1.7 RESPONSES TO LEISURE LAKE COMMENTS

Three comment letters and 30 form letters were received from residents of the Leisure Lake community opposing consideration of Storage Reservoir Study Area 3 as an alternative location of effluent storage reservoirs. In addition, a petition signed by over 150 people was submitted opposing Storage Reservoir Study Area 3.

Figure 7-6

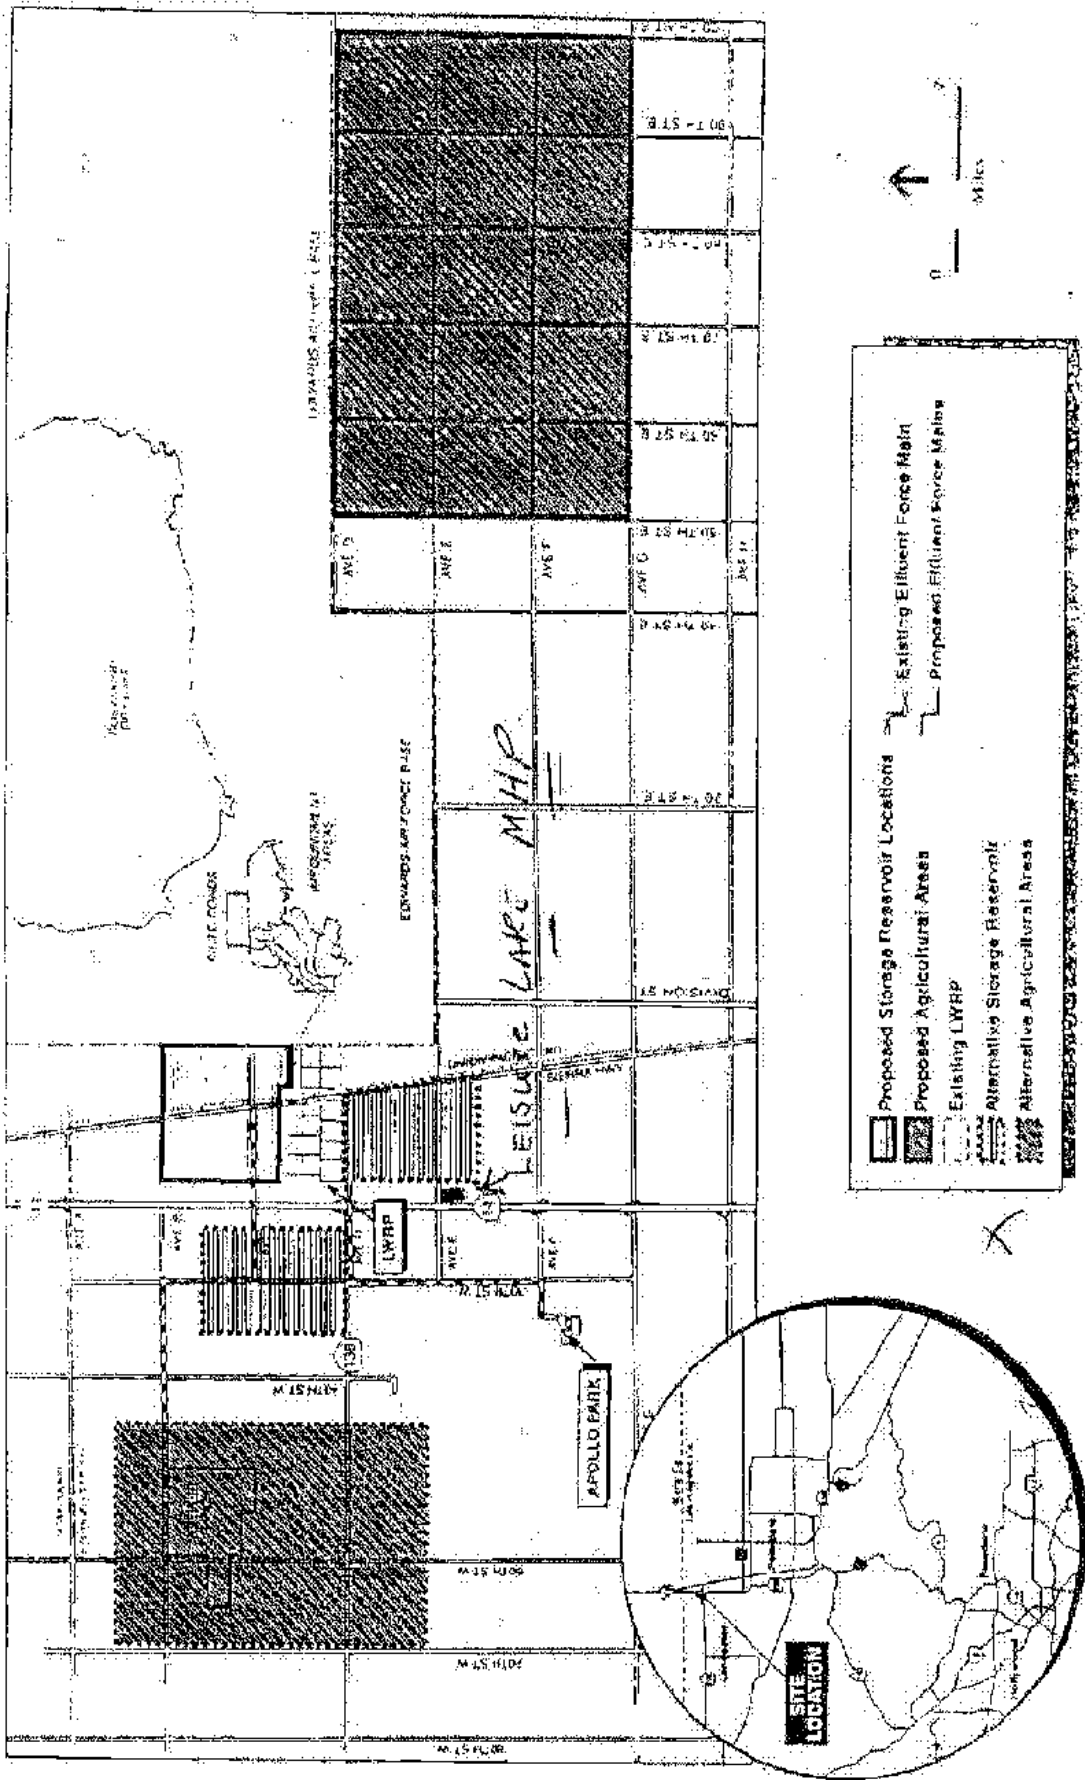
The proposed alternative storage reservoir (study area 3 on your figure 7-5) is directly east and northeast of Leisure Lake. This 211 space senior community is located at the corner of 20th West and Avenue E. My request is that you remove study area 3 from the map, as an alternative storage site, or for any other use on the LWRP 2020 plan. If not removed from the map, then I request an environmental impact study to determine the effect of the storage reservoir upon the senior citizens of Leisure Lake, including health issues, air quality, water wells (the source of water for the park), and property values.

The proposed alternative storage south of Avenue D should be eliminated from the LWRP 2020 Plan Storage Reservoirs, and no storage area or other use, should ever be considered south of Avenue D. I am enclosing copies of petitions, and letters from residents who are concerned about the impact of this project on their lives and future. Thank you for your consideration. Please send me a copy of the final recommendation when available.

The comment requests that Storage Reservoir Study Area 3 be removed from consideration in the Final EIR. Pursuant to CEQA requirements, the EIR must evaluate all reasonable alternative locations for each component of the project. Due to its proximity to the LWRP, Study Area 3 is a reasonable alternative location for storage reservoirs. Following an extensive evaluation process of a total of five alternative storage reservoir locations around the LWRP, District No. 14 eliminated Study Areas 1, 3, 4, and 5 from consideration and recommended that storage reservoirs be constructed in Study Area 2, which is north of the LWRP. The principal reason for rejecting Study Area 3 was the proximity of the Leisure Lake community near the intersection of Avenue E and SR-14. See Storage Reservoir Study Area 3 Master Response.

LRWP 2020 Plan EIR 7-2008
 Figure 1

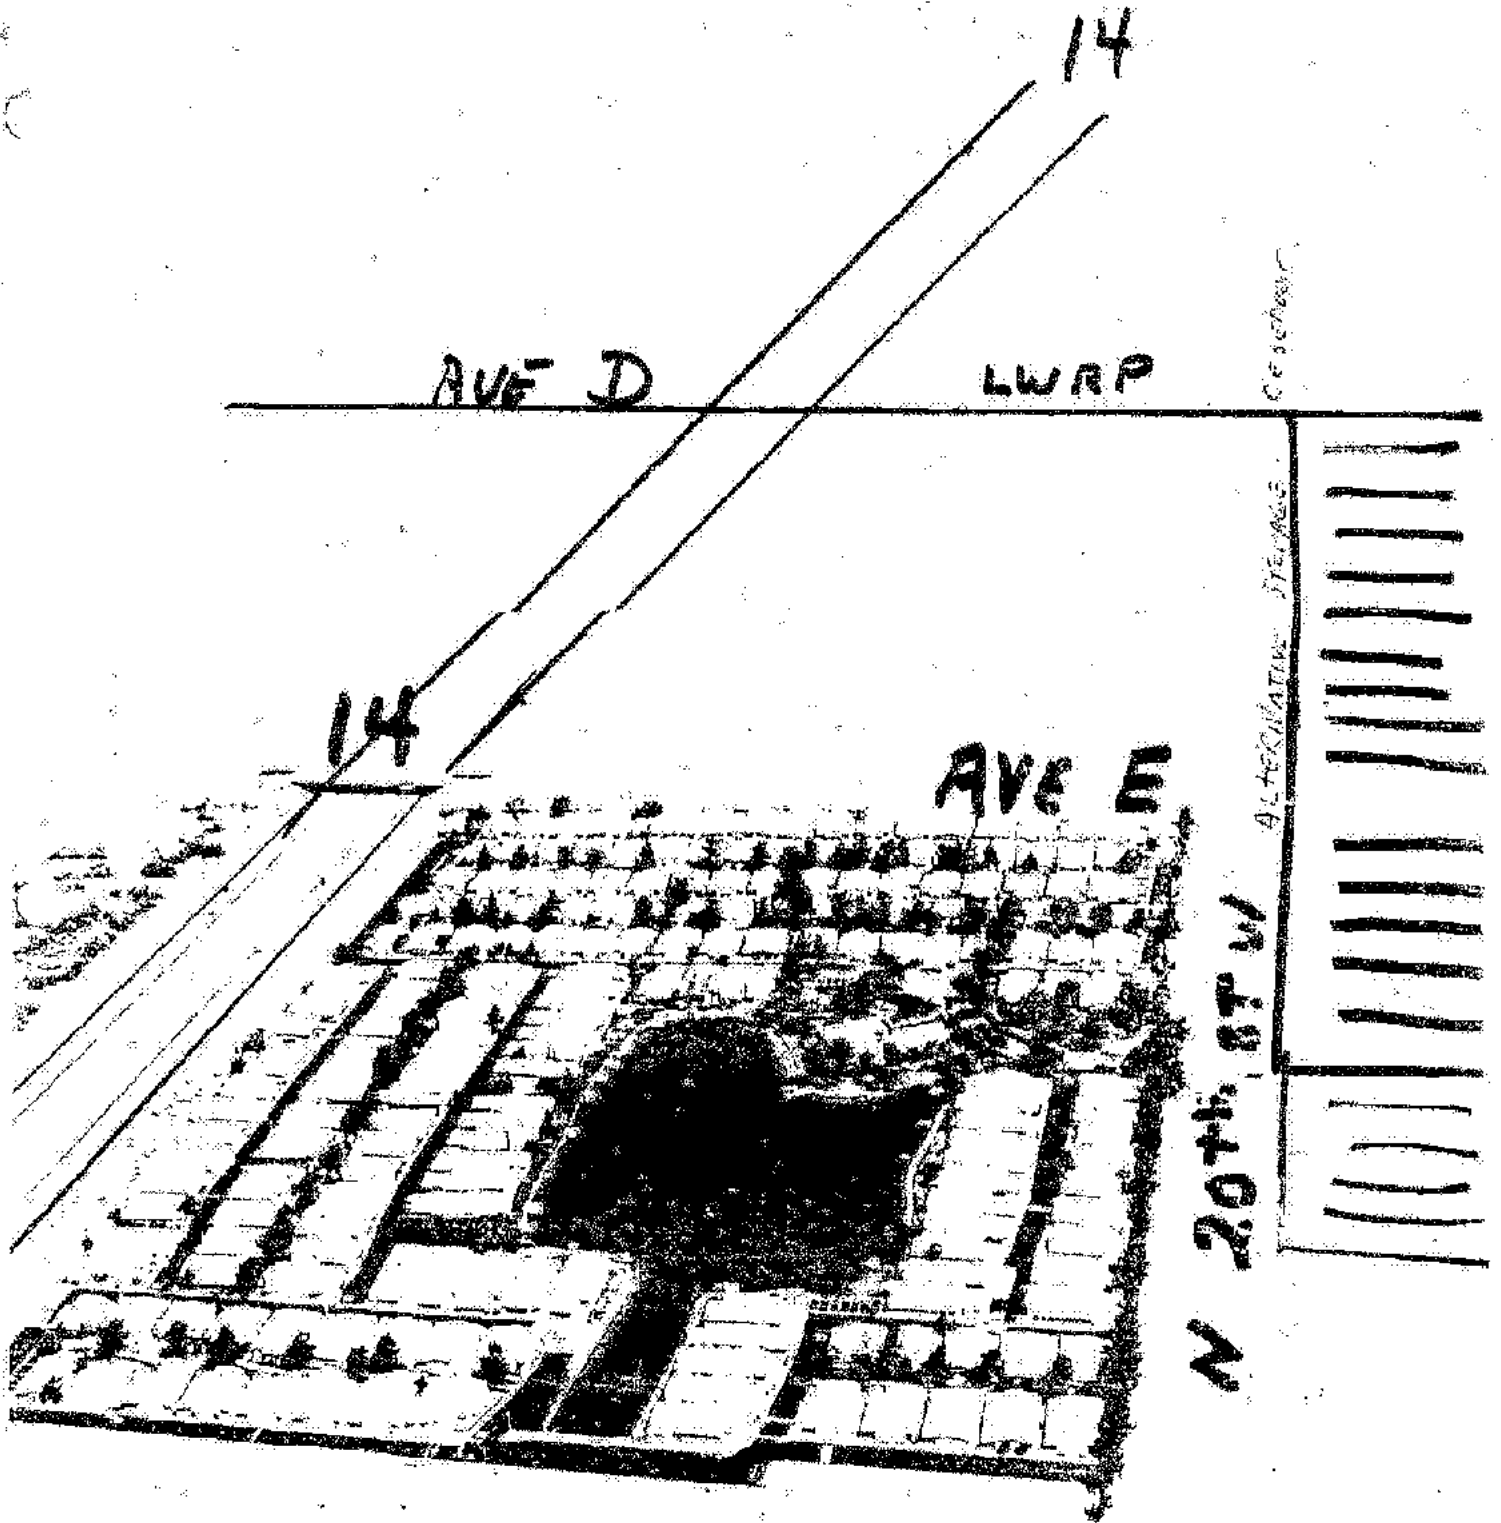
For the reasons stated above, the proposed alternative storage south of Avenue D should be eliminated from the LWRP 2020 Plan Storage Reservoirs, and no storage area should ever be considered south of Avenue D (see attached photos and map).
